Re: **Well Installation Work Plan Addendum**  
 1137-1167 65<sup>th</sup> Street  
 Oakland, California  
 Cambria Project # 522-1000  
 Case No. RO0000082

On behalf of John Nady, Cambria Environmental Technology, Inc. (Cambria) has prepared this *Well Installation Work Plan Addendum* (Addendum) for the above referenced site. This Addendum is based on a March 10, 2004 email and March 11, 2004 telephone discussions with the Alameda County Health Care Services Agency (ACHCSA) regarding Cambria's *Interim Investigation Data Report* (Interim Report) dated February 24, 2004. As requested by the ACHCSA, this Addendum proposes two additional wells in the Zone A water-bearing zone.

Proposed Monitoring Well Location Map

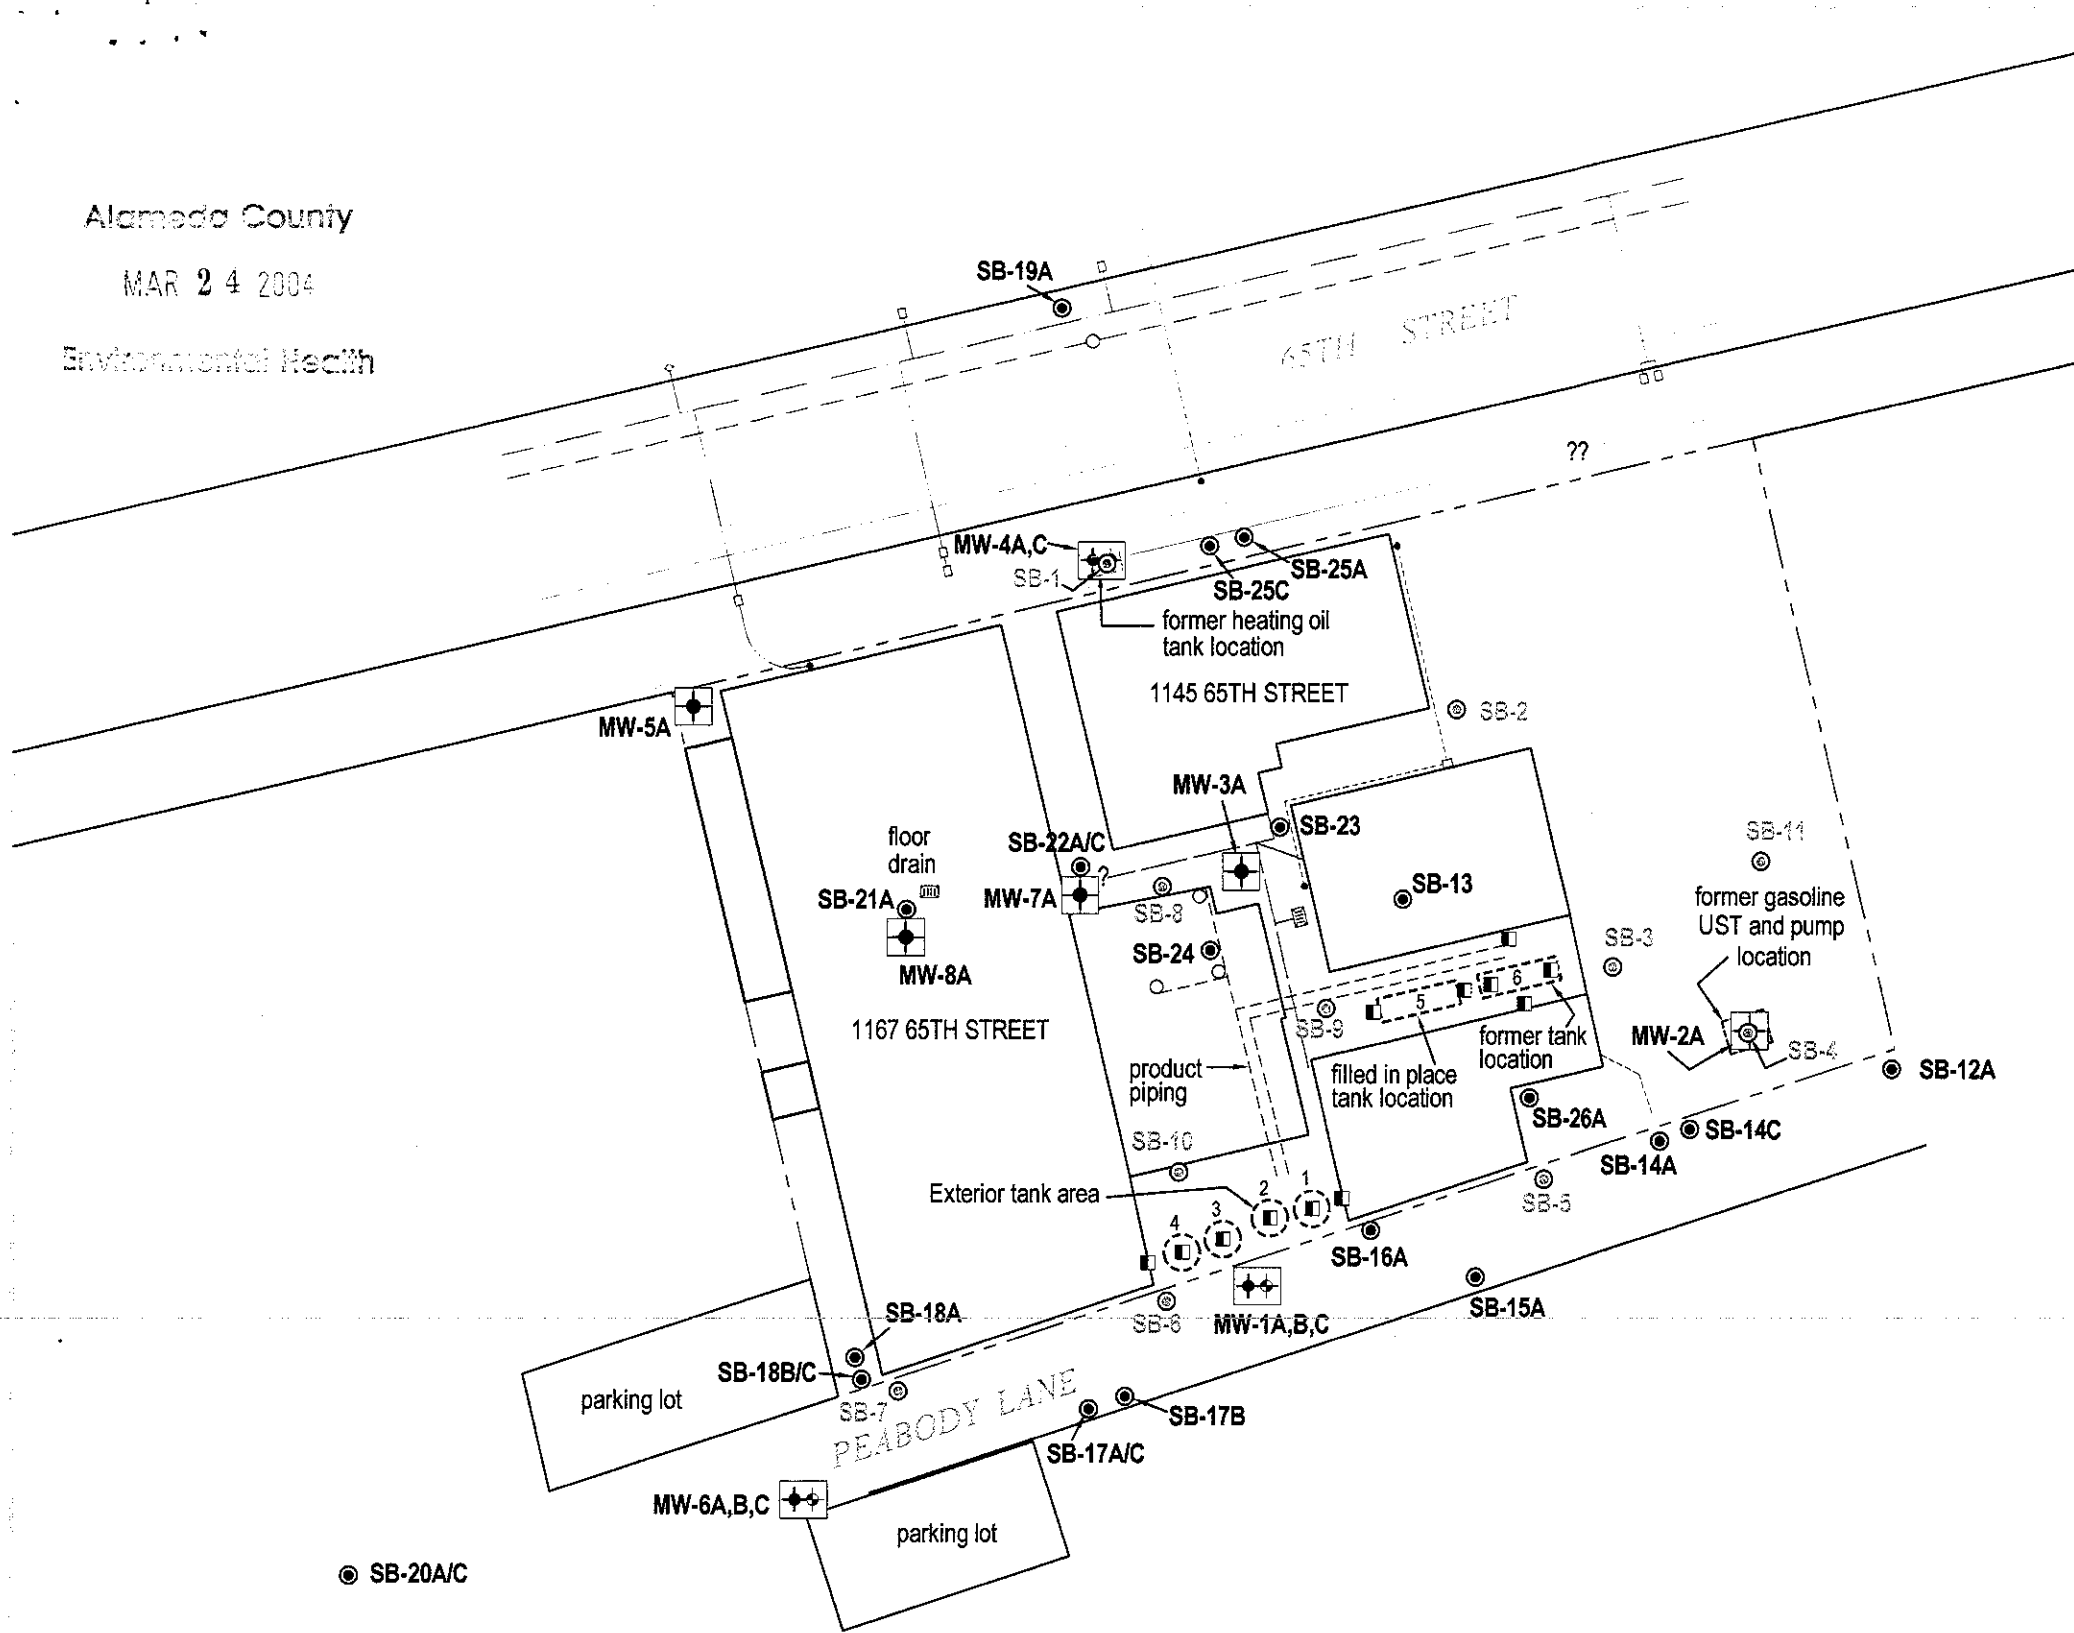
- \* Is there possible source near SB-21 and the floor drain? GW concentrations were high. Would it be possible to add a well near SB-21 or near the STEP boring just sw of SB-21?
- \* Is it possible/reasonable to have a mw near the inner tanks 5&6 since we know there is high residual soil contamination left in place.
- \* Could the location of proposed well MW3 be moved west, near SB-8 which exhibited very high soil and gw concentrations?

The Interim Report proposes installation of the following wells in the A, B, and C water-bearing zones: MW-1A through MW-6A; MW-1B and MW-6B; and MW-1C, MW-4C, and MW-6C. The additional scope of work to be performed by Cambria will include the drilling and installation of the following two monitoring wells screened across the Zone A water-bearing zone (see Figure 1):

- Monitoring well MW-7A will be in the vicinity of previous boring SB-22.
- Monitoring well MW-8A will be in the vicinity of previous boring SB-21, and drilled using a hand auger to install a pre-packed well.

As we discussed during our March 11, 2004 telephone discussion, Cambria is not proposing a well in the vicinity of the former inner tanks 5 and 6 due to tank 5 having been filled in place and no shallow groundwater encountered in previous borings in the vicinity (SB-3 and SB-9).
